SEGA OF AMERICA, INC.
Consumer Products Division

32X H/W Information

Doc. #-MAR-25-R5/R6-060694

32X H/W Information (1)

(2) Crystal exchange of the main board

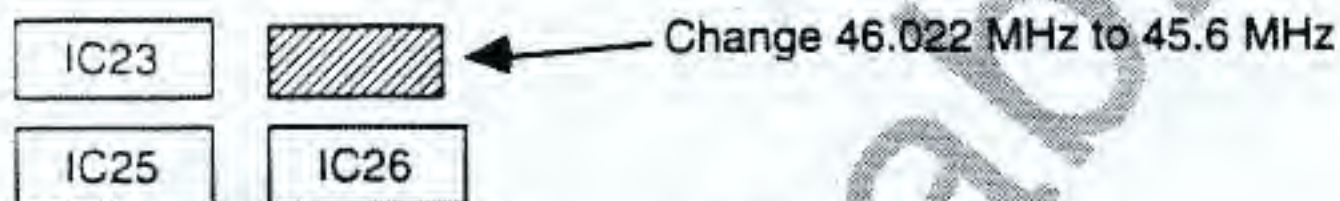
9. The following countermeasures should be performed in response to PAL.

• For Target Ver. 1.0

(1) Dip switch changes of the main board
DIPSW1-2 is on

• For Target Ver. 1.1

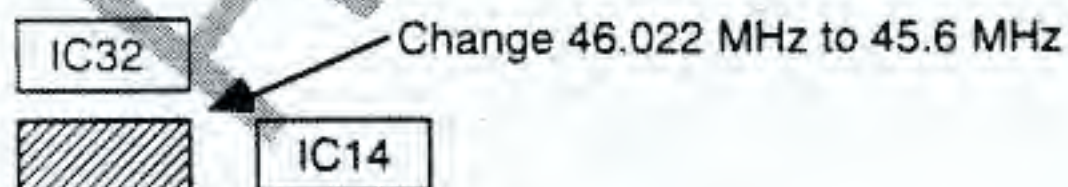
(1) (2) are the same as in Target Ver. 1.0.
(3) Crystal exchange of the I/F board

(4) Change in VDP board Dip switch
DIPSW1-1 is on

• Modification Method of the 32 Mbit SRAM W/BUP Board

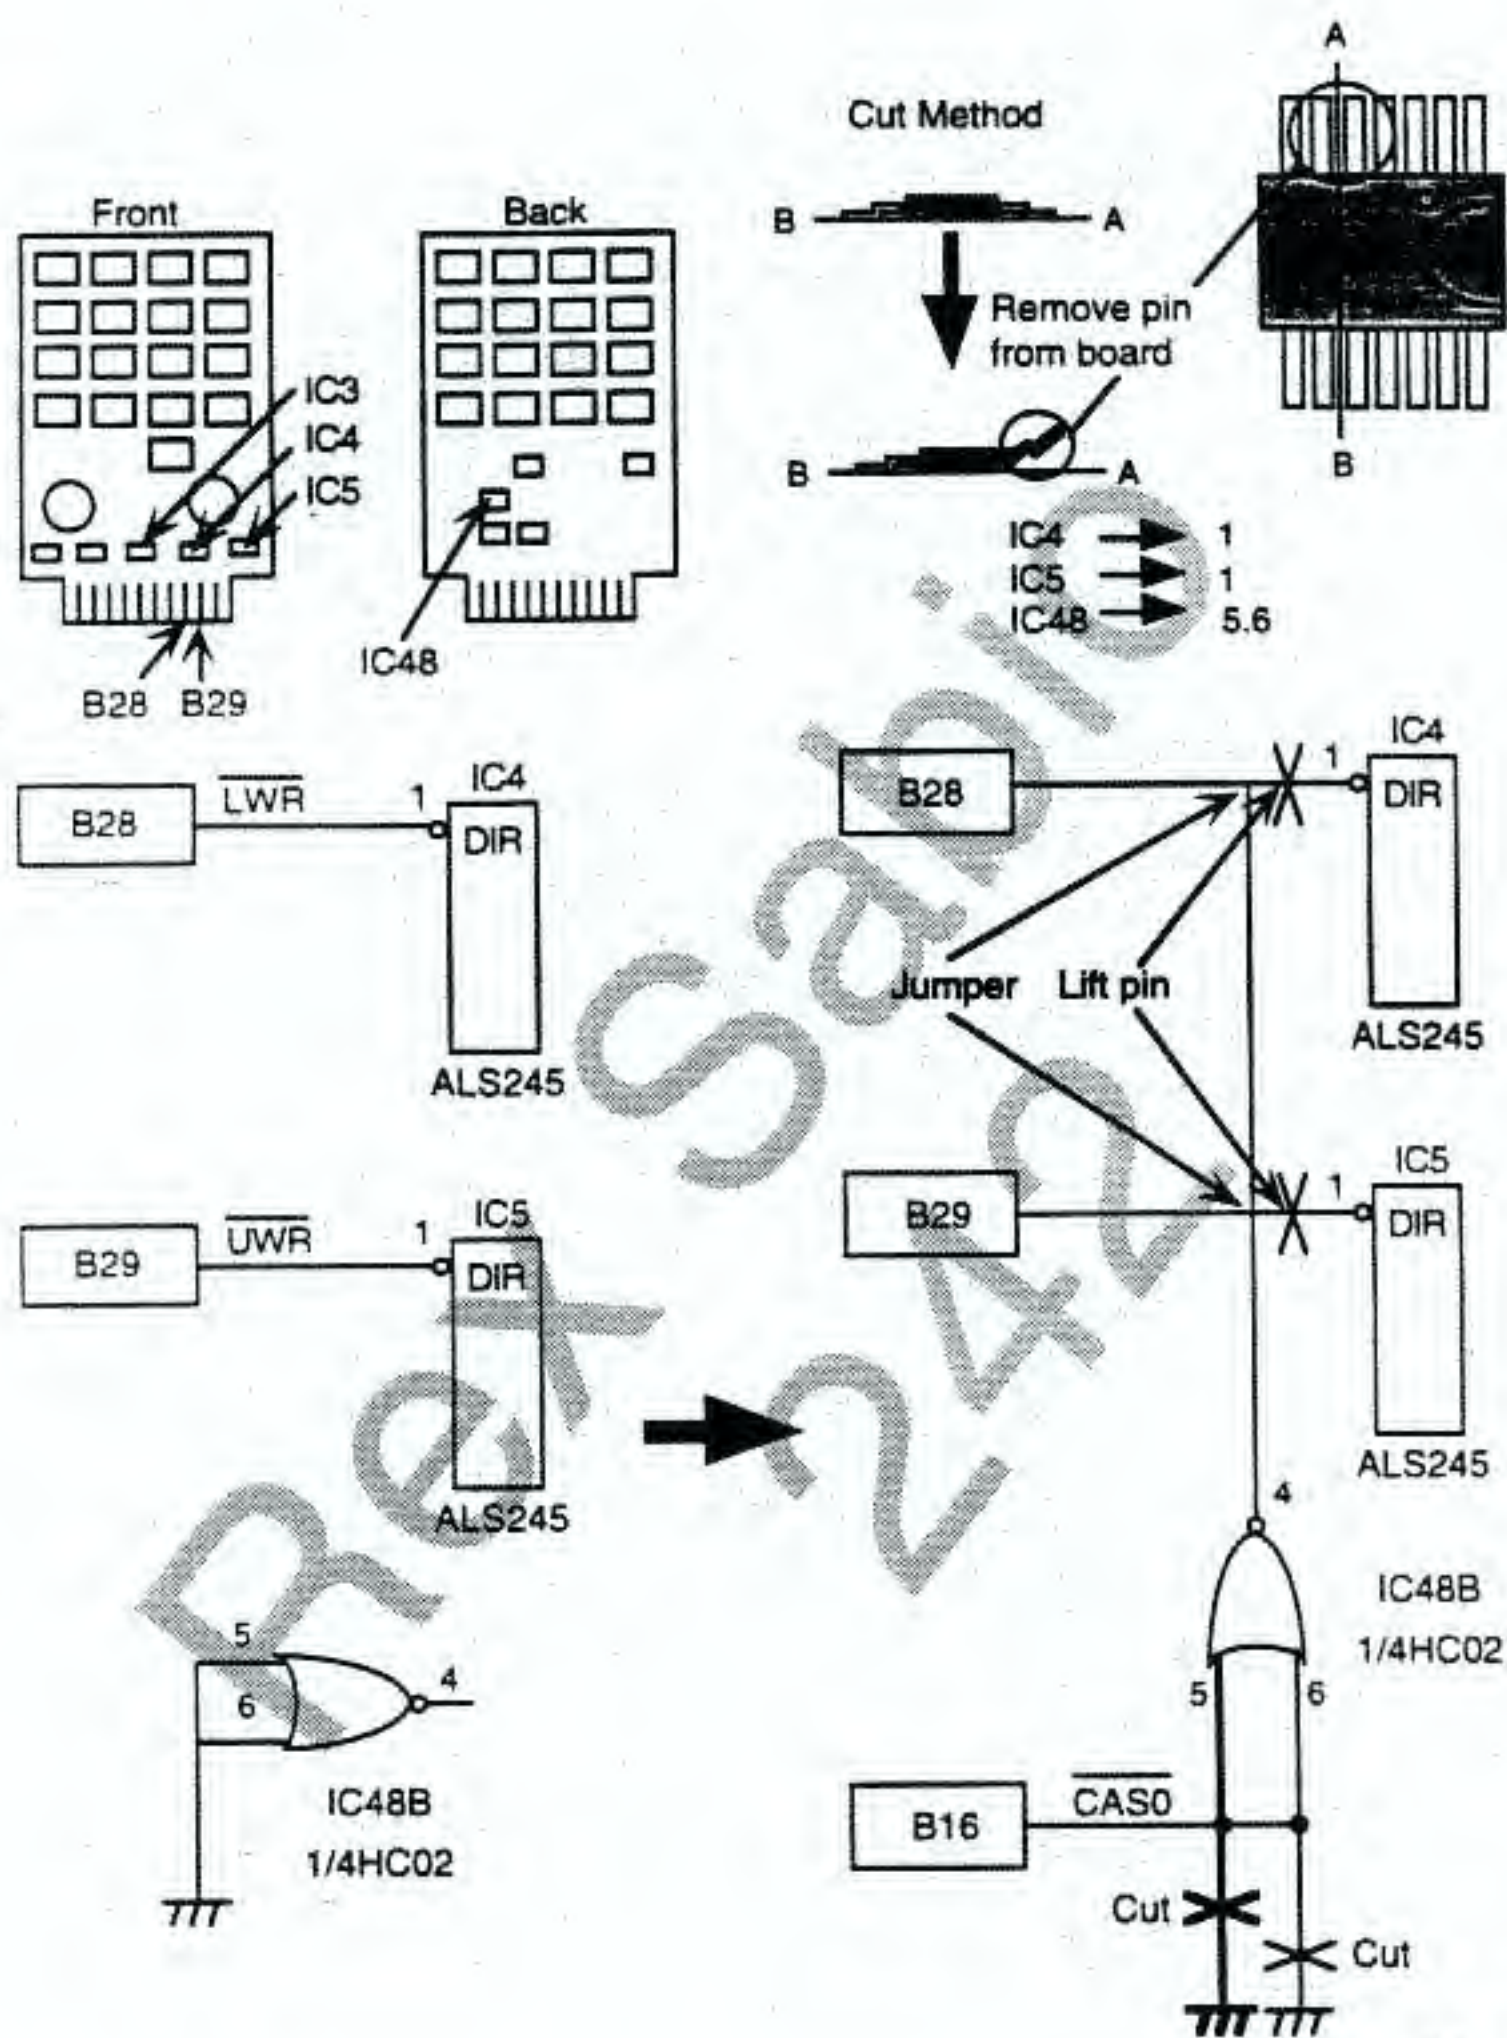
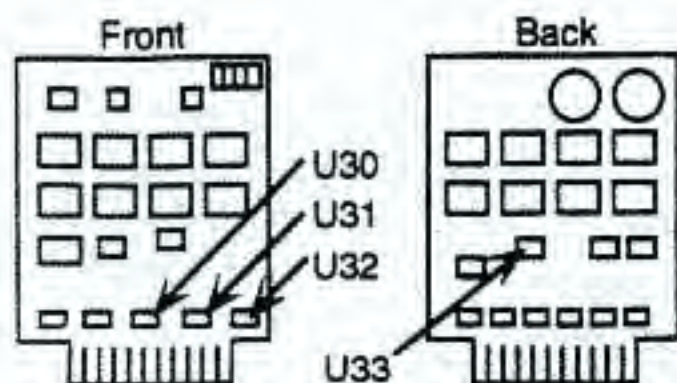
3. Precautions when using a 32 Mbit SRAM board.
 - The 32 Mbit SRAM W/BUP board mis-reads data on the SH2 RAM board when both 68000 and SH2 are running.
 - The modifications on the next page are required for 32X development.
 - There are no problems when running 68000 and SH2 independently.
 - There is no need for modifying MD development.

Work Procedure

1. Lift pin 1 of U31 and U32.
2. Lift pins 13, 14, and 15 of U33.
3. Add jumper between pin 16 of U30 and pins 13 and 14 of U33.
4. Connect pin 15 of U33 to GND (pin 8).
5. Add jumper between pin 9 of U33 and pin 1 of each U31 and U32.
